STATE OF HAWAII
DEPARTMENT OF TRANSPORTATION
HIGHWAYS DIVISION

DEMOLITION & GRADING PLAN

OAHU DISTRICT WAREHOUSE BUILDING

Project No. HWY-0-05-98

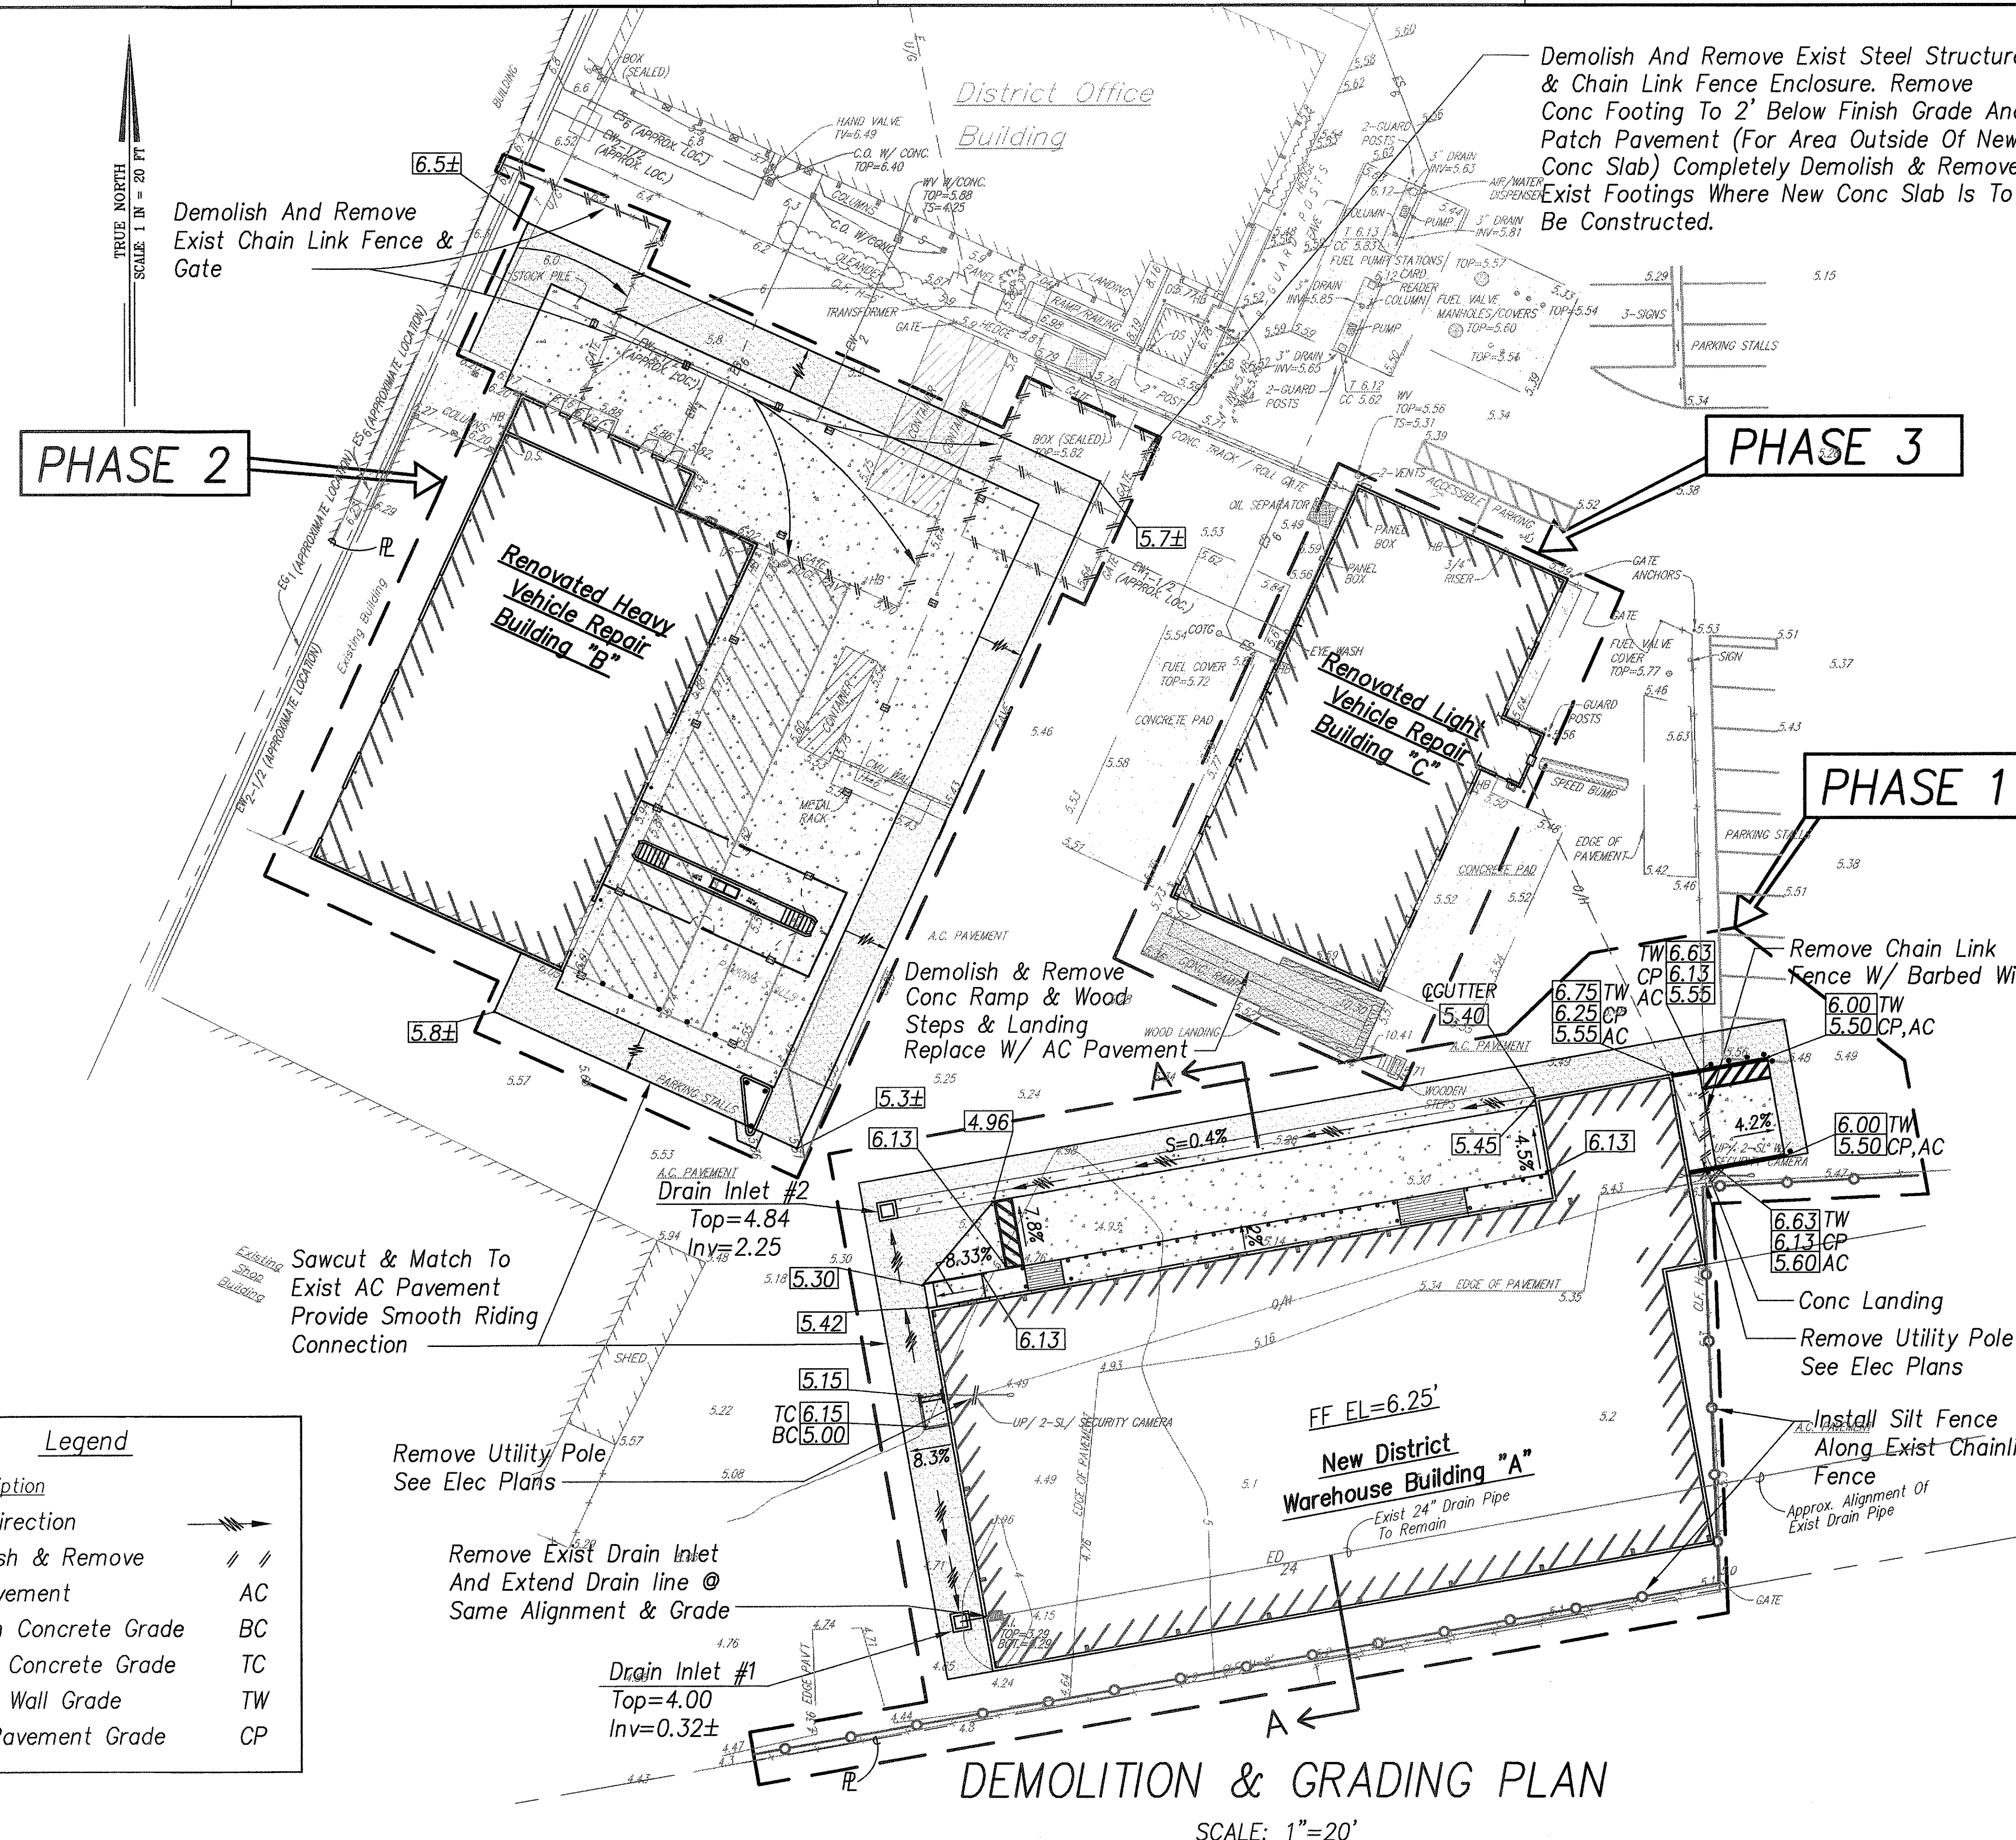
7/20/2000	PCD 1 Clarification
June 2000	Revised Dewatering Notes 1, Add Note 2 & Legend
Date	Revision

SITE & UTILITY PLAN

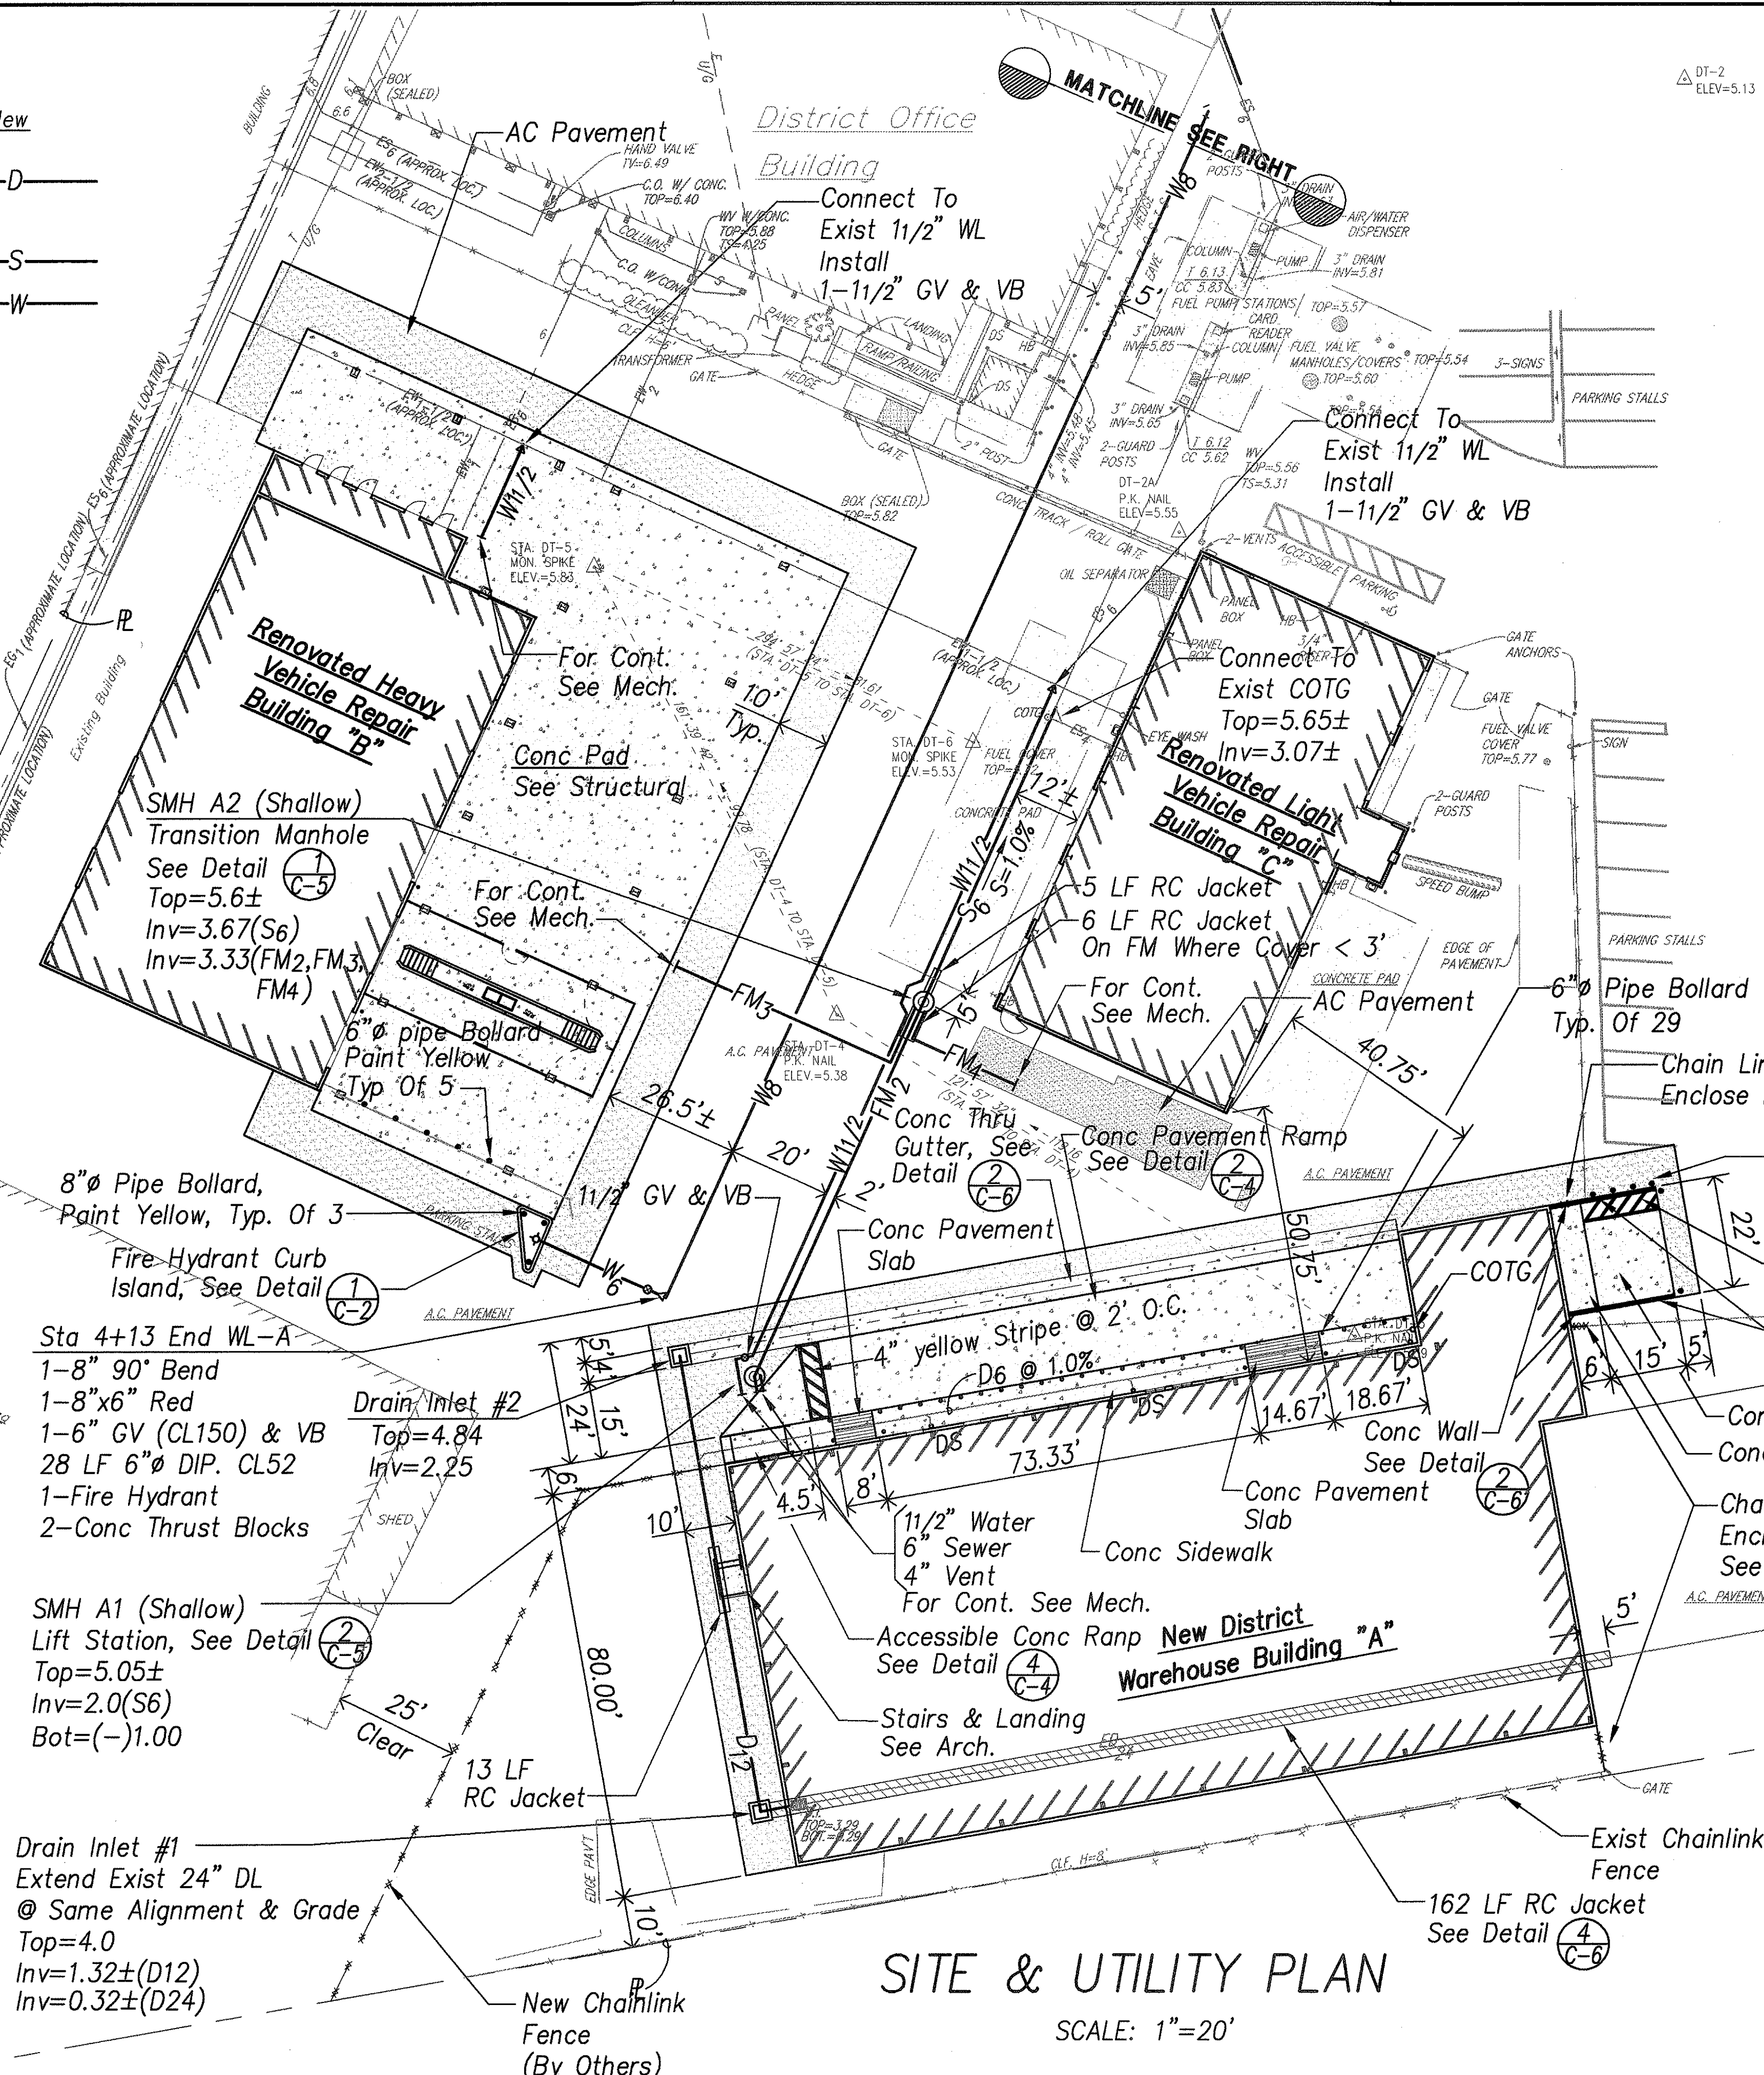
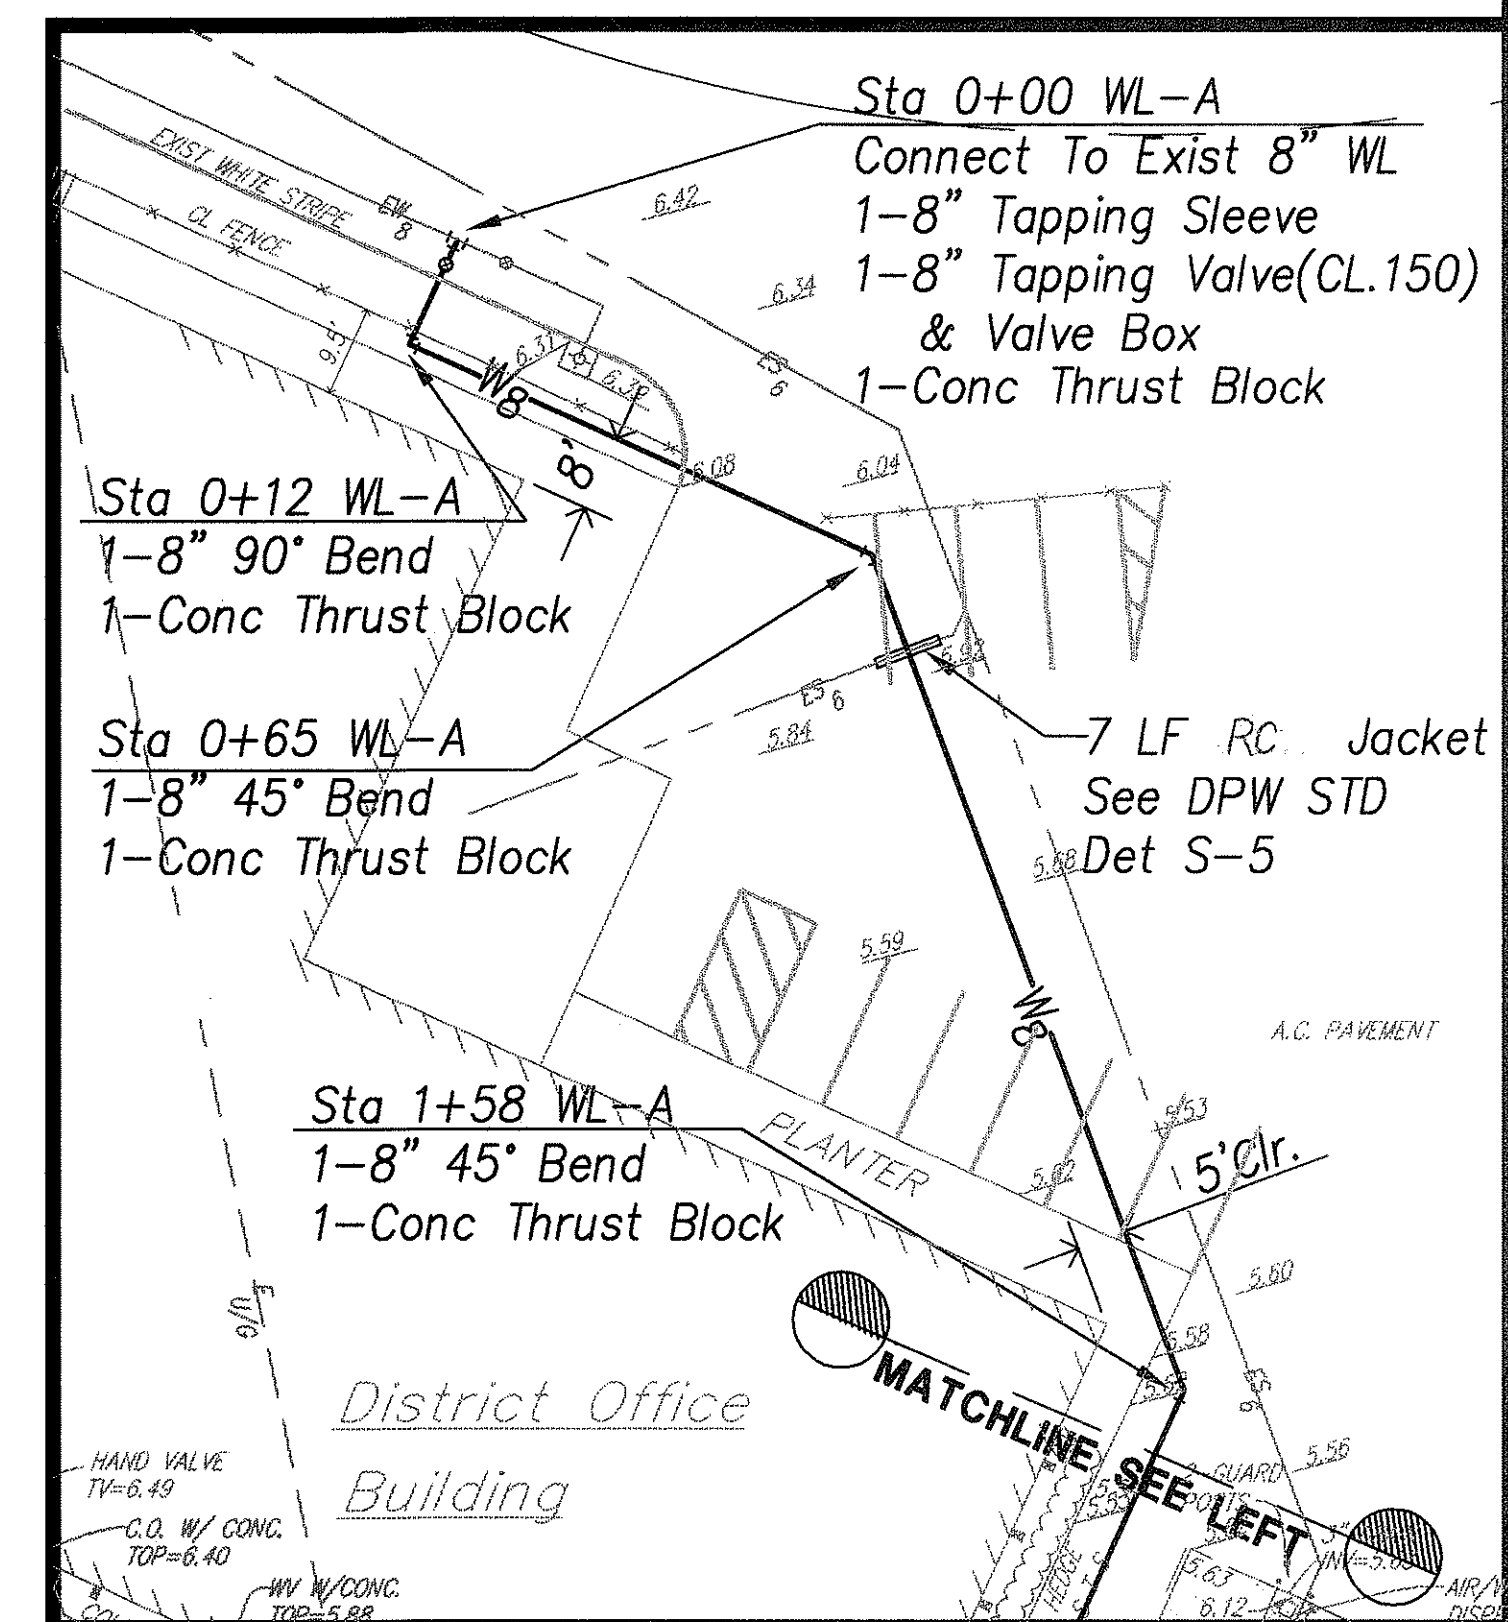
C-2	Rev. Note 8, FM TO BLDG "C", Add Striping @ Ramp, Note 9, Conc Jacket
June 2000	
Date	Revision
STATE OF HAWAII DEPARTMENT OF TRANSPORTATION HIGHWAYS DIVISION	
SITE & UTILITY PLAN OAHU DISTRICT WAREHOUSE BUILDING Project No. HWY-0-05-98 Scale: AS SHOWN Date: APRIL 2000	
SHEET No. C2 OF 116 SHEETS
